**PLANNING COMMISSION
MEETING
May 11, 2023
4:00 PM**

The Dental Suite, LLC.
 Site Plan & Architectural Review
 2301 Chestnut Street
 May 4, 2023

LAYOUT PLAN
ALTMANN CONSTRUCTION
DOOLITTLE OFFICE ADDITION
CITY OF WISCONSIN RAPIDS
WOOD CO, WISCONSIN

5) Landscaping

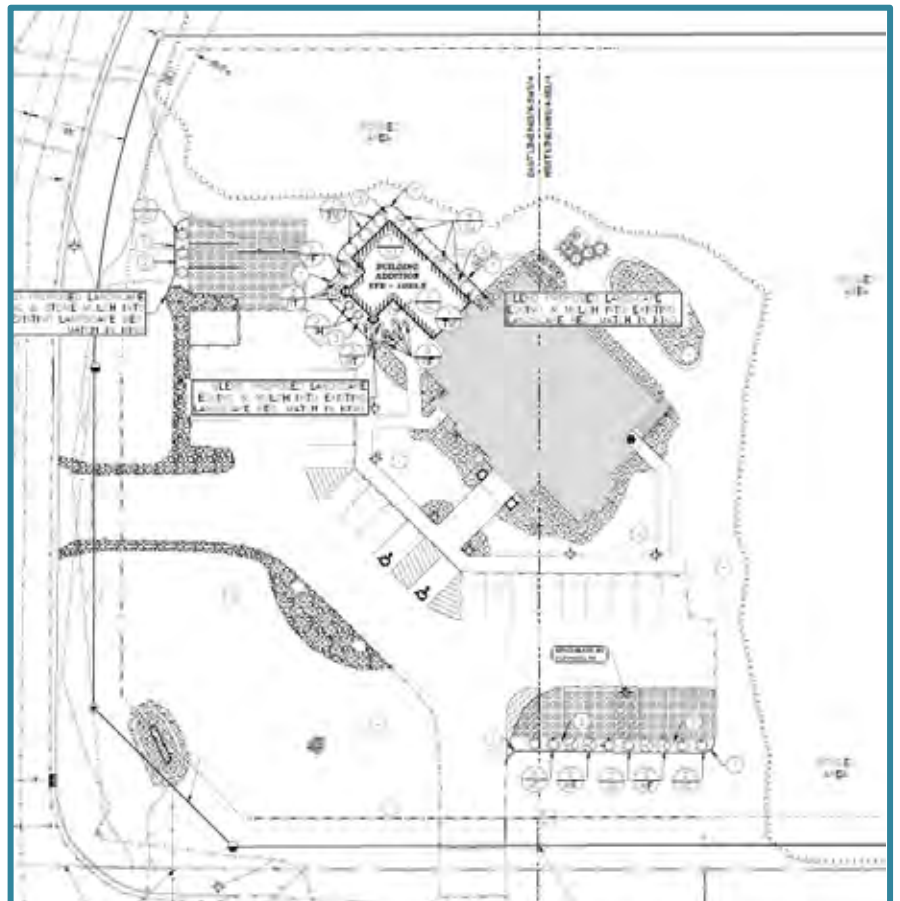
Analysis: The proposed addition creates the need to meet foundation planting requirements and the additional paved area creates the need to meet parking lot points requirements. There are 133 linear feet of building being added, requiring 53 foundation points. The additional 2,504 square feet of paved area, for a total of 26 points. A total of 85 square feet must be located within the paved area perimeter. The Woodlands Business Center Protective Covenants requires that all setback areas be considered “tree preservation zones”. No trees greater than six inches diameter and four feet above existing grade be removed without special permission from the City. Setbacks at this location are 50 feet from both street frontages and 30 feet rear.

Findings: A landscaping plan has been submitted. A total of 57 foundation landscaping points are proposed including a mix of medium and low evergreen and deciduous shrubs. In addition, 31 parking lot points are proposed. Chapter 11 – Zoning requires that 60% of the points be devoted to tall trees. Because tall trees are a minimum of 30 points and 26 points total area required, the proposed points are sufficient. There are 8 trees proposed to be removed as part of this proposal, however none are within the required setback areas.

6) Architectural Review

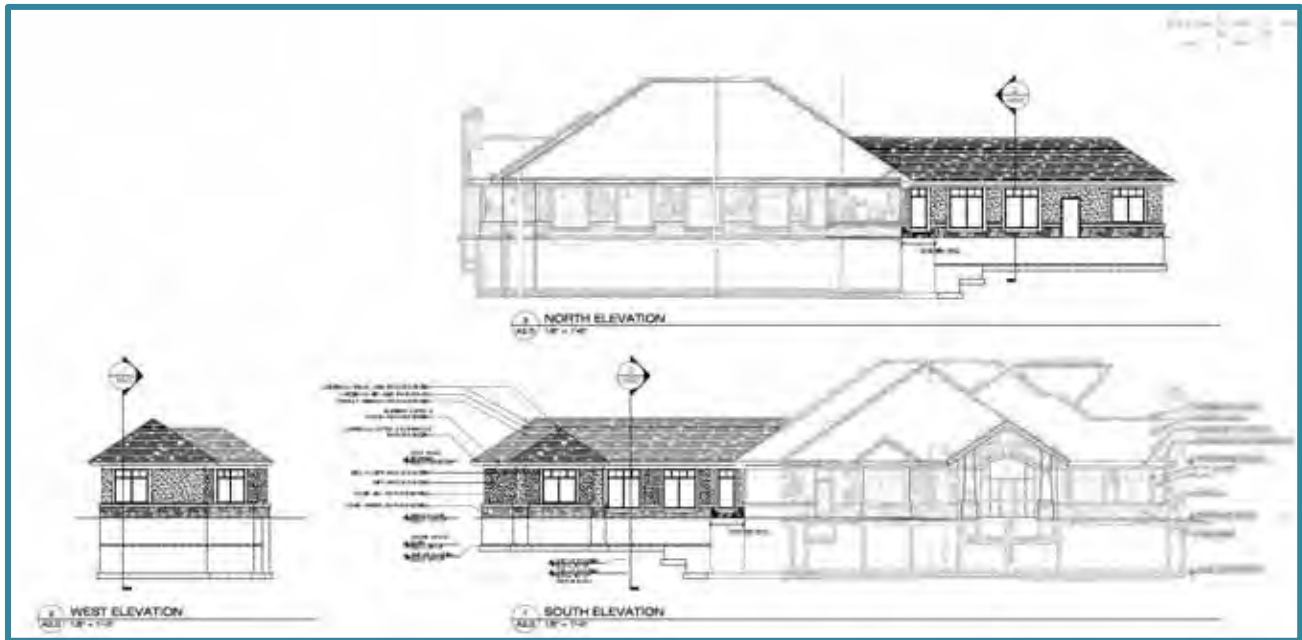
Analysis: Renderings have been submitted, showing façade finishing materials primarily of EIFS, accent EIFS, and a stone veneer base with stone sill to match existing. Additionally columnar elements and bump out accents have been incorporated to match the existing structure. The new windows include mullions (vertical beams) and transom elements (horizontal beams) to add visual interest and to match the existing windows.

Findings: The exterior materials proposed for the commercial building addition will blend nicely with the existing structure. From an architectural standpoint, the style and form of the addition ties well into the existing commercial building and includes a nice blend of materials and features. The south elevation is most visible from the street side and includes the highest level of enhancement.
